# THE VILLAS AT CLAREMONT RANCH

## CONSTRUCTION DRAWINGS

### STREET IMPROVEMENTS PLANS

## STORM SEWER PLANS

(E) EXISTING	(P) PROPOSED
(C) CURB AND GUTTER	(C&G)
BOUNDARY	---
RIGHT-OF-WAY	---
LOT LINE	---
(E) CONTOUR, INDEX	6800
(E) CONTOUR	---
(P) CONTOUR, INDEX	6800
(P) CONTOUR	---
(P) STORM SEWER	---

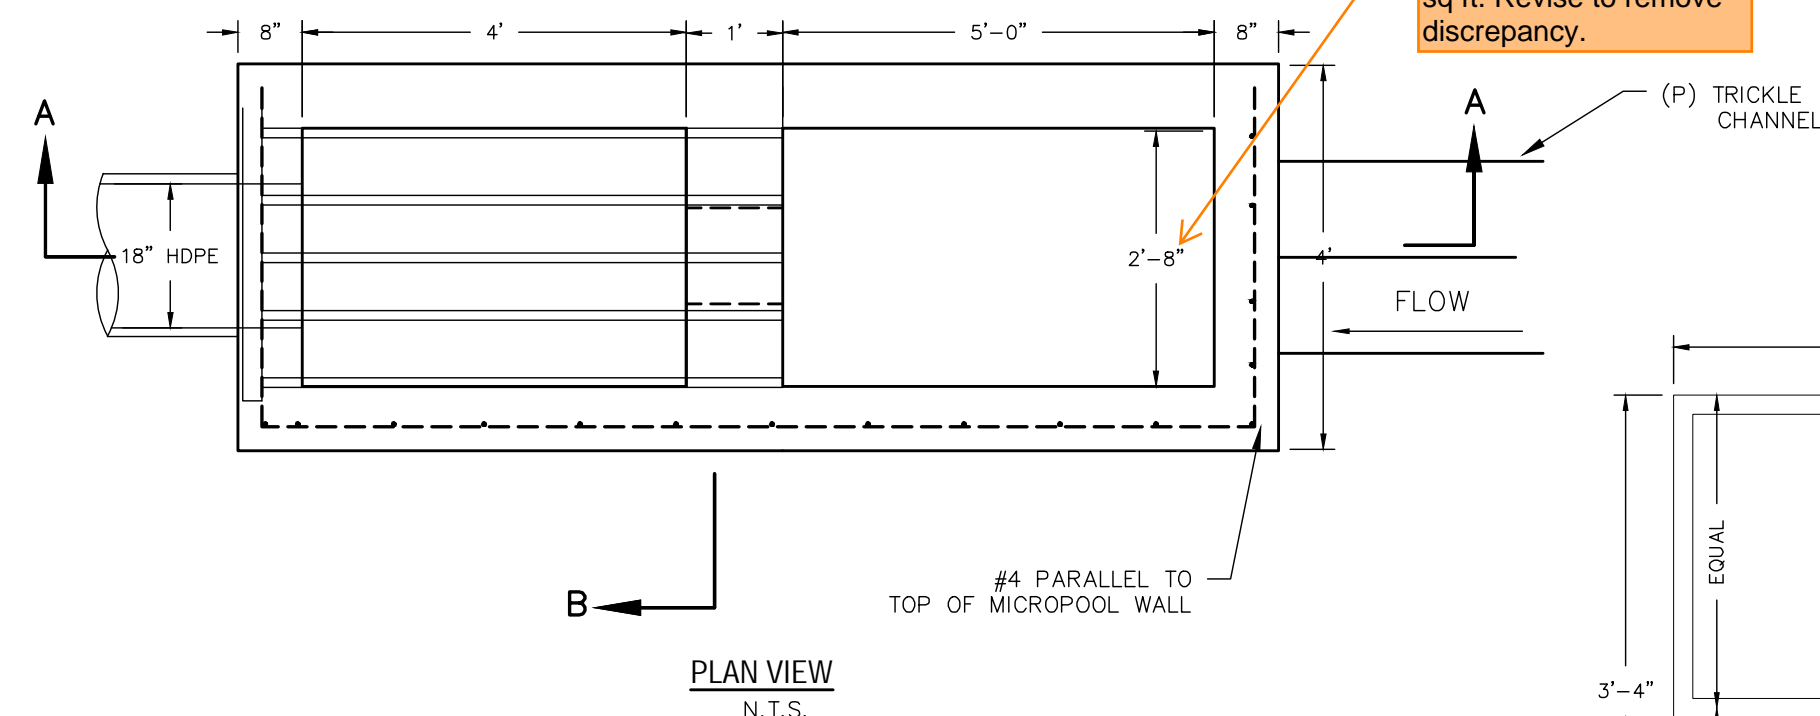
Provide details for: trickle channel, access road, handrail

Shouldn't these elevations match?

Since the UD Detention spreadsheet calcs were updated in the FDR, this value is now 4.7'

How will this be constructed without a detail in plan view? Please provide one.
